UNITED STATES PATENT AND TRADEMARK OFFICE

10/772,979

Office Action Summary

DETAILED ACTION

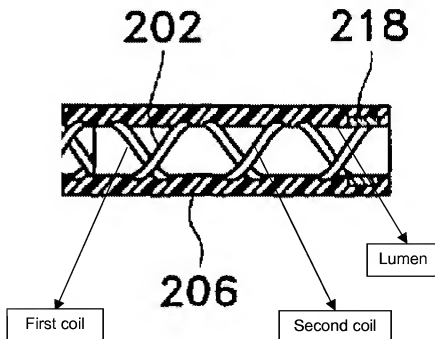
5. (claim 1) The Chien reference discloses a sheath capable of deploying an embolic filter, the sheath comprising:

an elongate shaft **200** having a distal end and a lumen (see Fig. 2);

a coil assembly **202** including:

a first coil defining a lumen, the first coil being wound in a first direction (see attached portion of Fig. 2),

a second coil wound in a second direction, the second coil being disposed around the first coil (as seen below, the second coil is disposed around the first coil);

wherein the coil assembly is attached to the distal end **206** of the shaft, and the lumen of the shaft is in fluid communication with the lumen of the first coil (see attached portion of Fig. 2, below).

Chien discloses a dual coil reinforcement of a hollow tube, wherein the first coil and second coil are braided/weaved around each other. Chien fails to teach the second coil being wound about an outer surface of the first coil.
